IEEE 802.16 Broadband Wireless Access Working Group <<http://ieee802.org/16>>

Title **Comments on Frame Structure for multi-hop relay**

Date Submitted **2007-1-18**

Re: Response to call for technical contributions on 80216j-06_027, "Call for Technical Proposals regarding IEEE Project P802.16j", Sep.15,2006

Figure 2. Example of minimum configuration for an in-band non-transparent relay frame structure (Suggested as a replacement to Figure xyz in [1]).

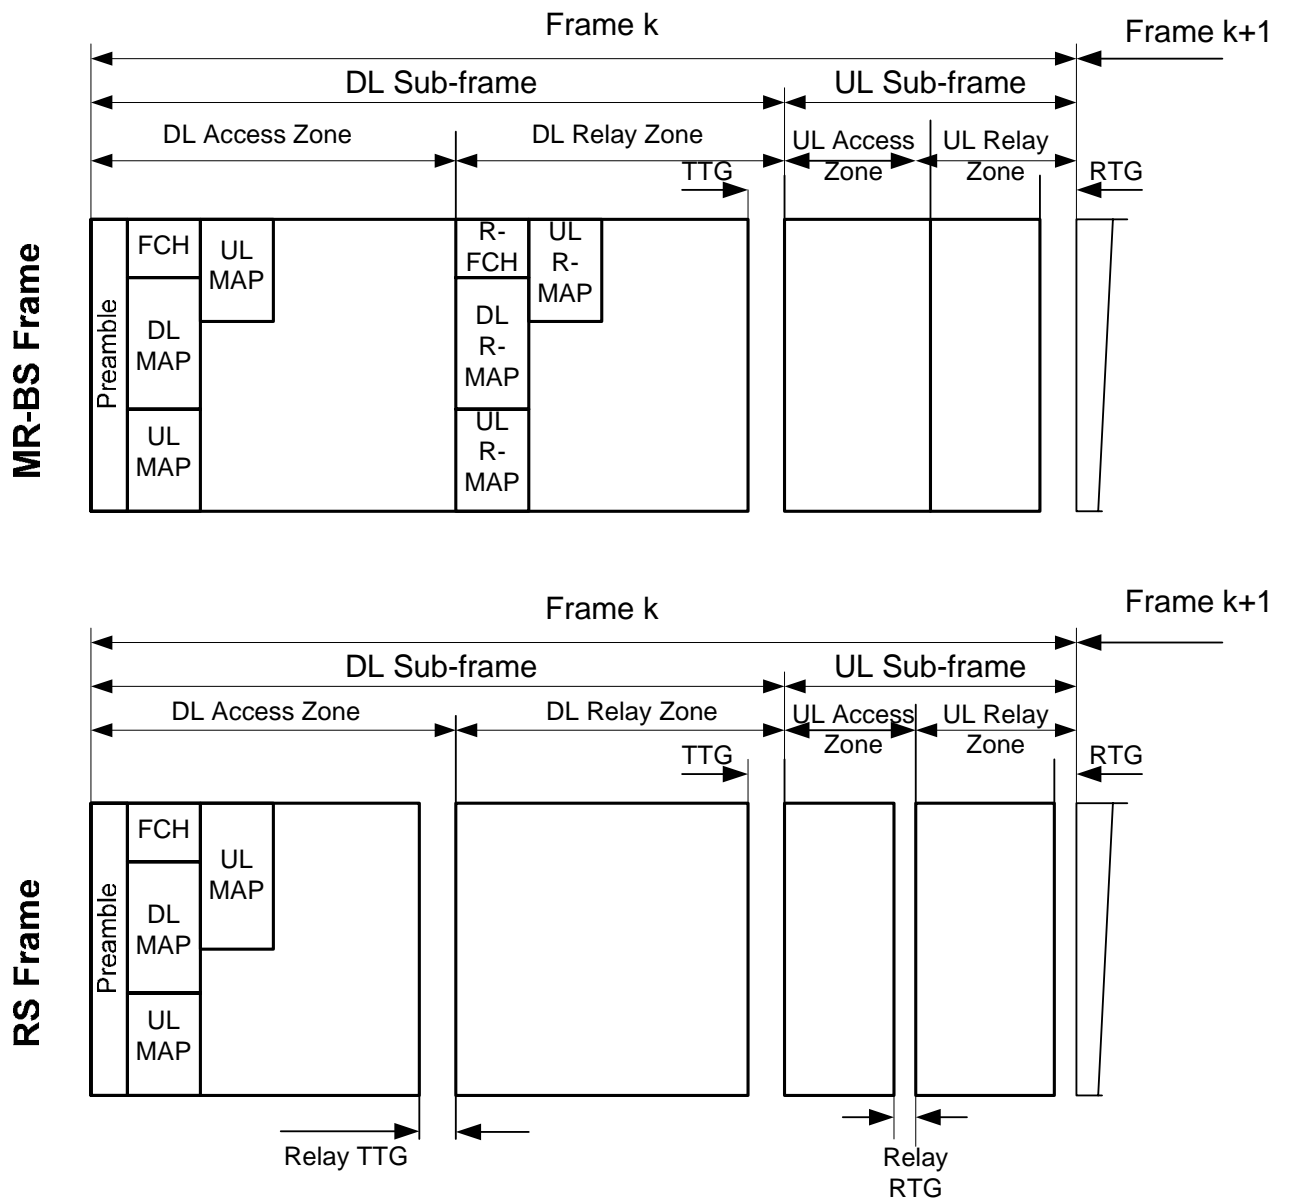
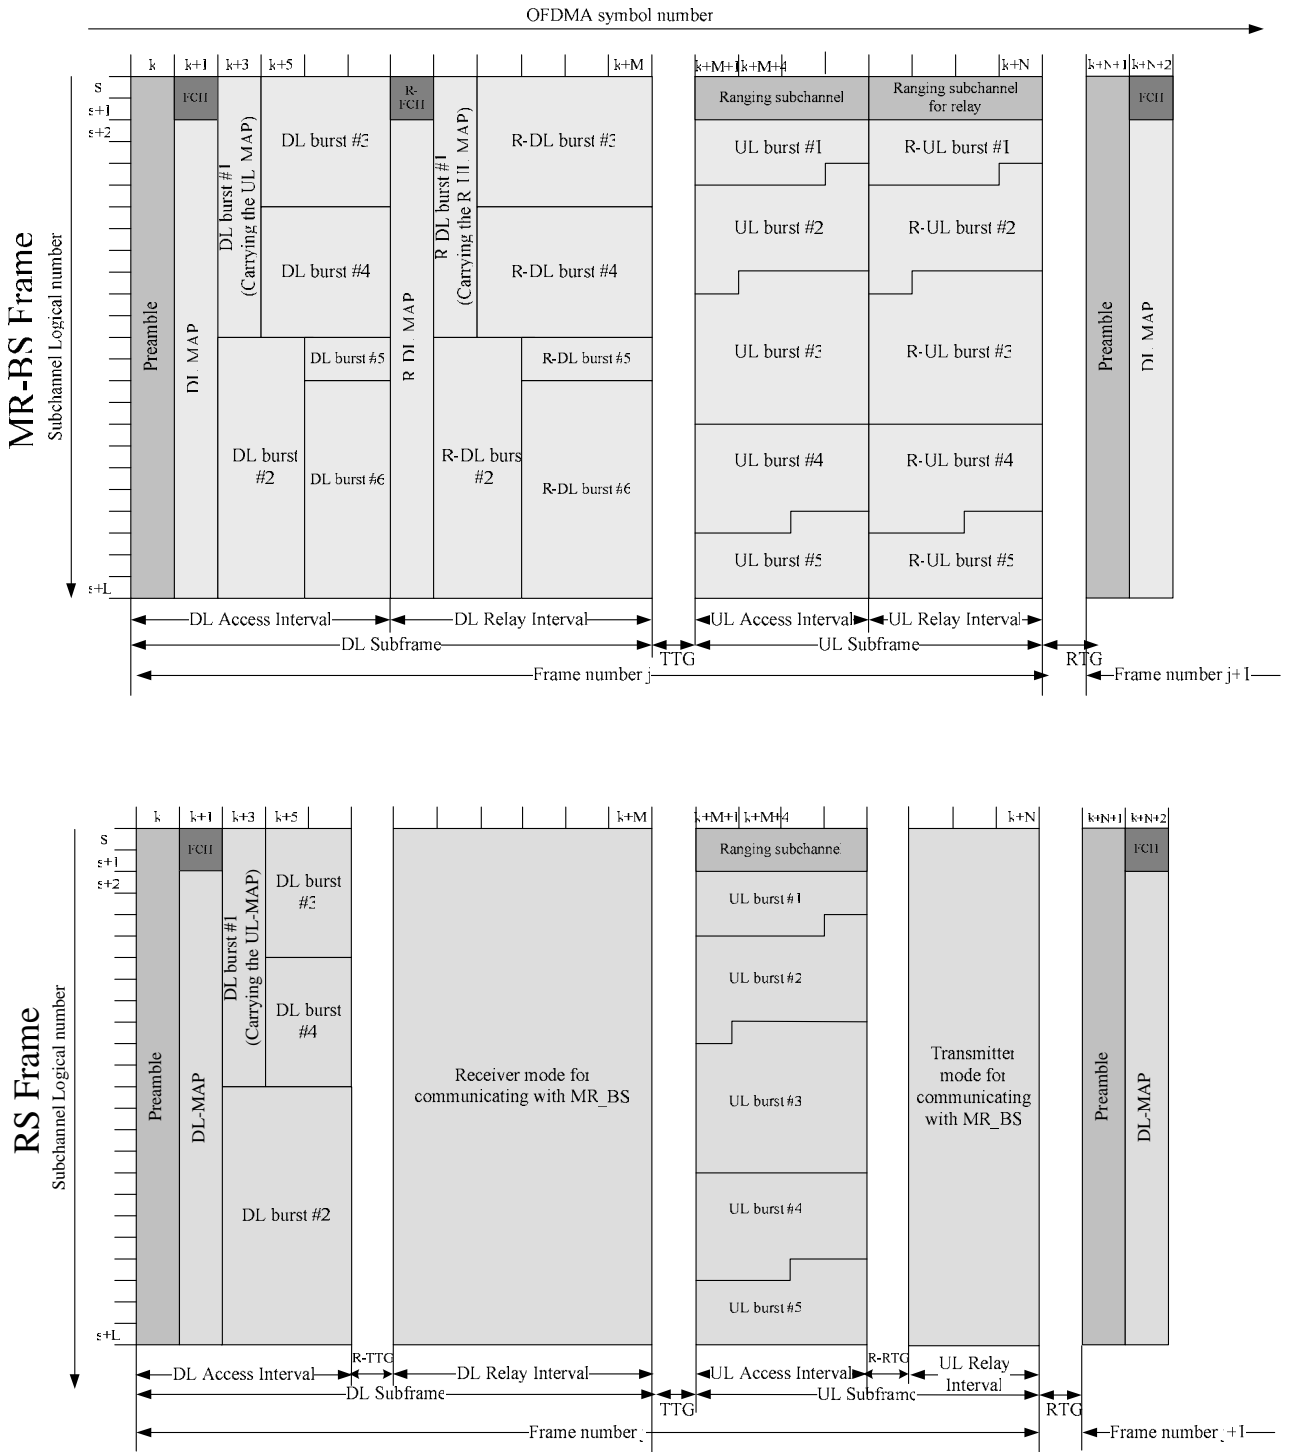
Figure 1 shows the minimum configuration of frame structure as agreed in the last meeting, i.e., a frame structure for two-hop relay. In this contribution Figure 2 is proposed with an aim to align Figure 1 such that it provides a similar level of detail as Figure 218 in the current specification .. In addition, it is argued that the term ‘zone’ used in the minimum configuration of frame structure may cause confusion when used together with the already existing terminology ‘zone’ as used in Figure 219, for instance. So, it is proposed that the term ‘zone’ as implied in [1] be replaced by the term ‘interval’ to avoid confusion.

Figure 3. Relay frame with multiple intervals

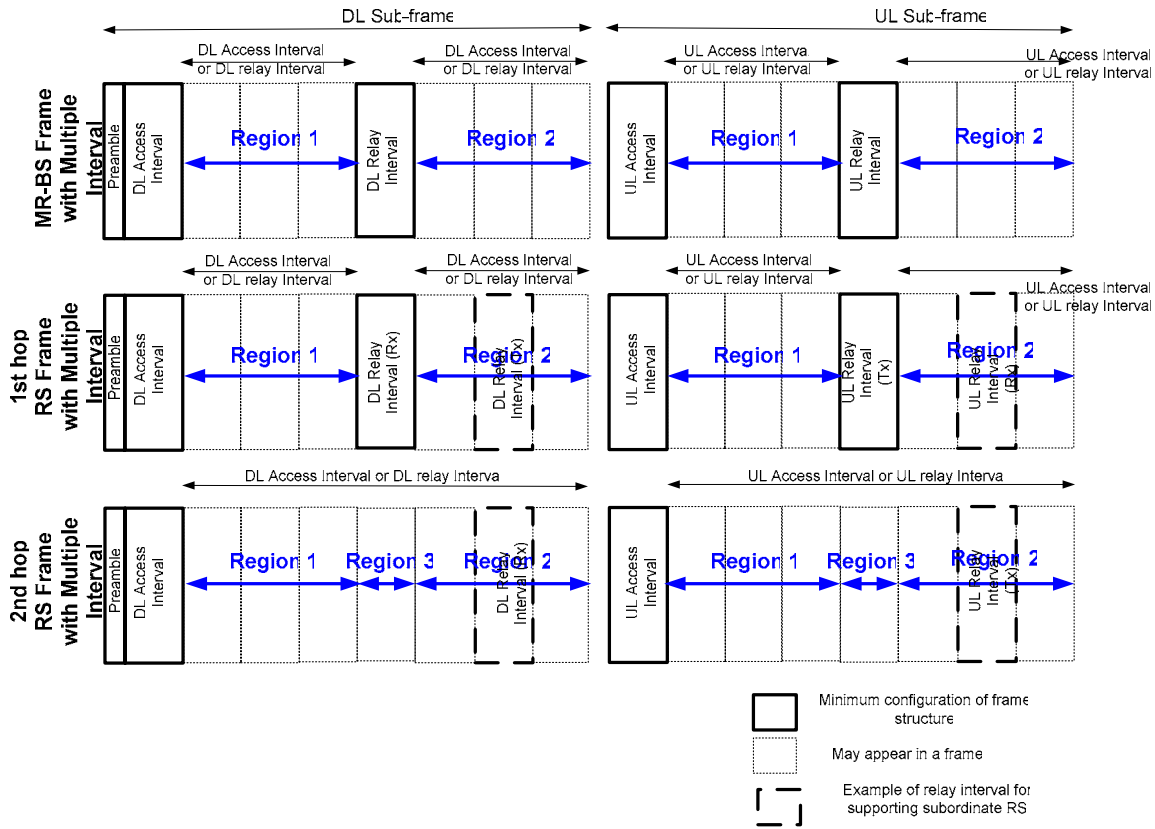
More importantly, to support multi-hop relay, the agreed minimum configuration of frame structure needs to be extended. Just as Figure 219 in the current specification [2] generalizes Figure 218, Figure 3 is provided as a generalization of Figure 2, to accommodate various frame configurations for supporting the multi-hop topology. According to the generalization illustrated in Figure 3, additional intervals to allow multi-hop capability may appear in a frame based on the minimum configuration of frame structure.

To be more specific, MR-BS frame and RS frame may have additional DL/UL access interval after the DL/UL relay interval to support its MSs. Alternatively, an RS frame may have additional DL/UL relay interval either before the DL/UL relay interval or after the DL/UL relay interval to support its subordinate RS. However, the number of additional interval may need to be limited for technical feasibility.

Note that the additional access intervals shall not include FCH and DL-MAP, while the additional relay interval may include R-FCH and R-DL-MAP.

Figure yyy Example of minimum configuration for an in-band non-transparent relay frame structure

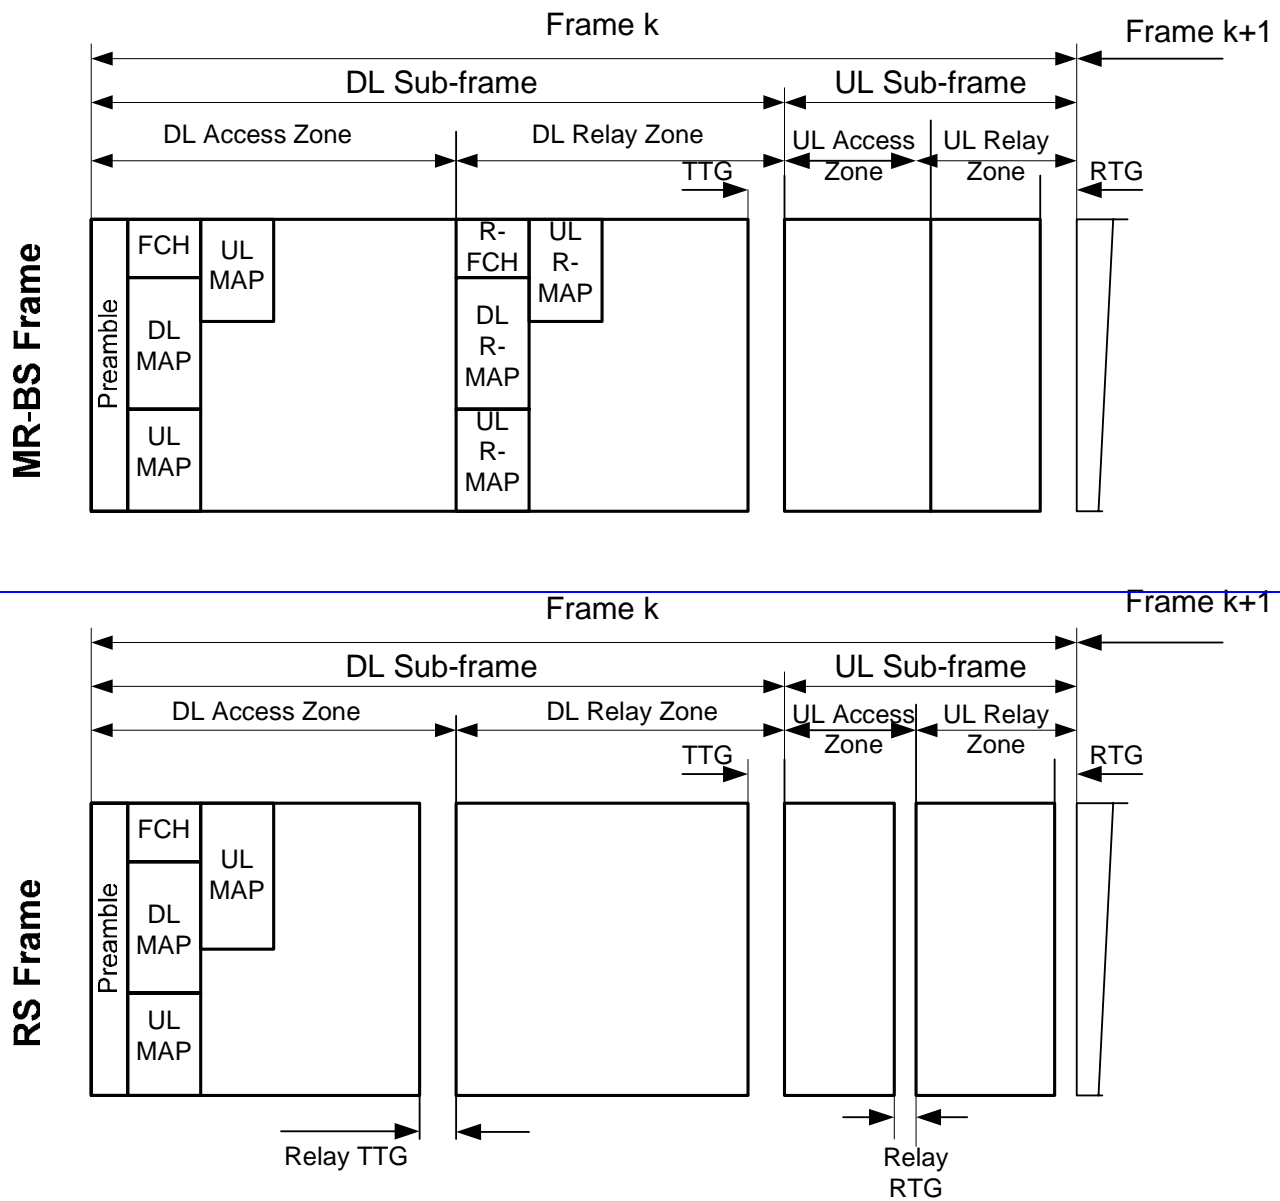
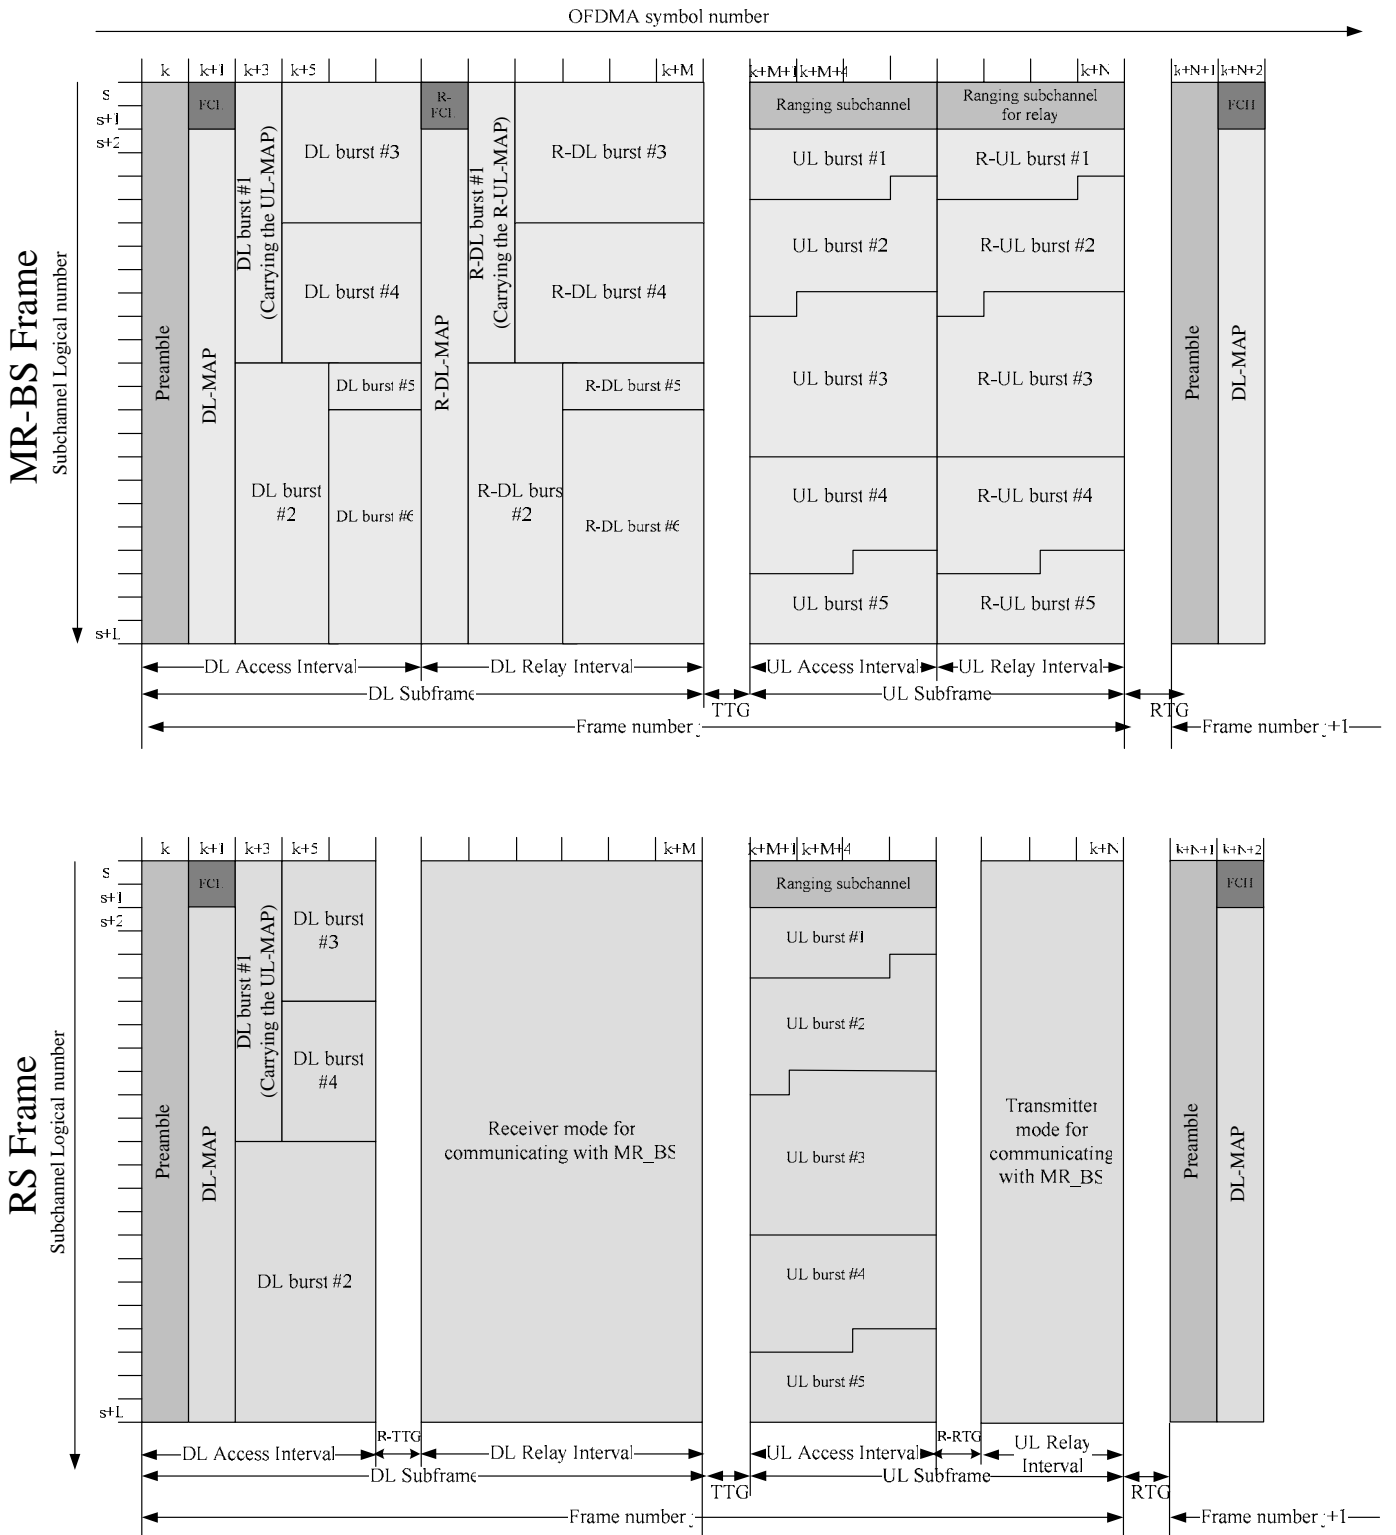
[Remedy 2: Replace Figure]

[Replace Figure xxx with Figure yyy as follows:]

Figure zzz Relay frame with multiple intervals

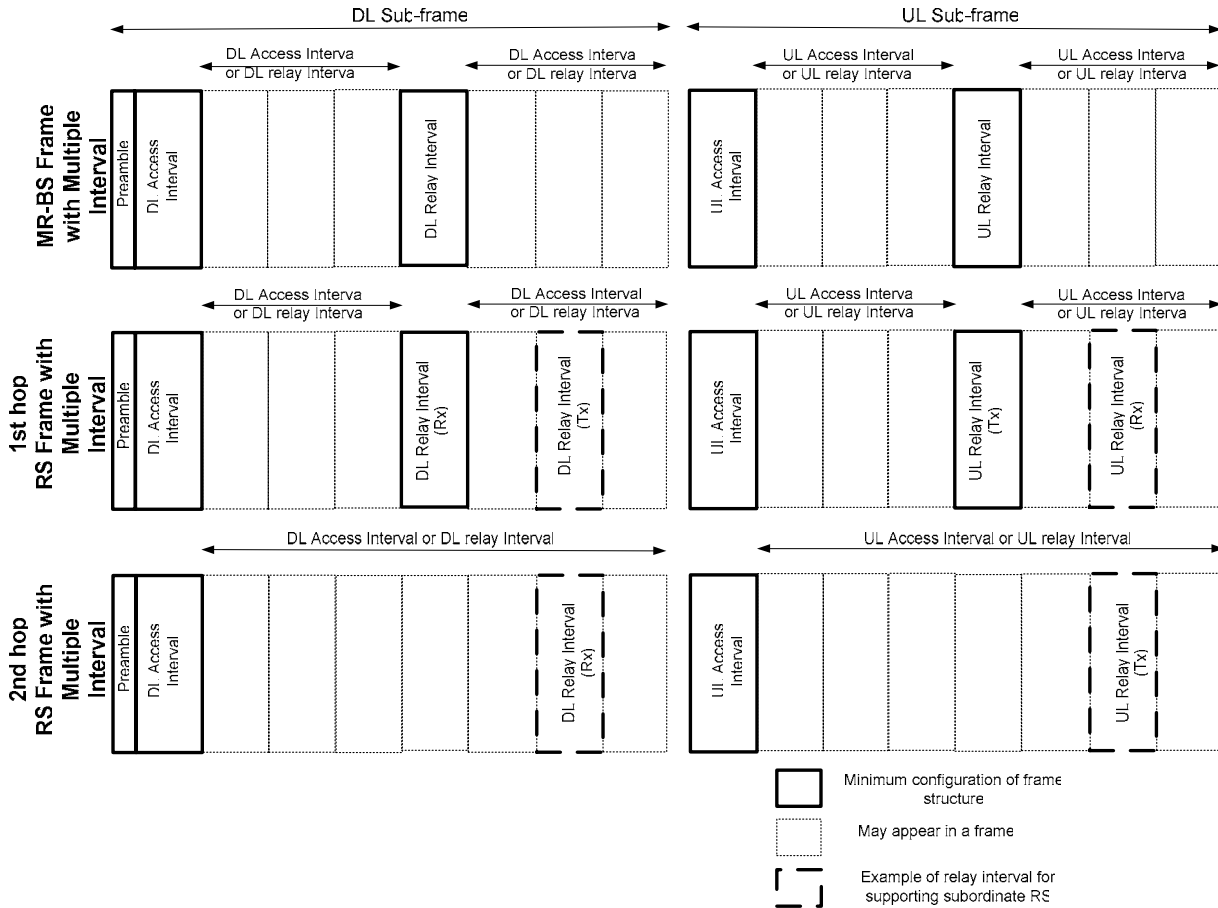
[Remedy 3: Insert Figure]

[Insert Figure zzz at the end of section 8.4.4.7.2 .2]

Figure yyy depicts the BS frame and the RS frame with multiple intervals.
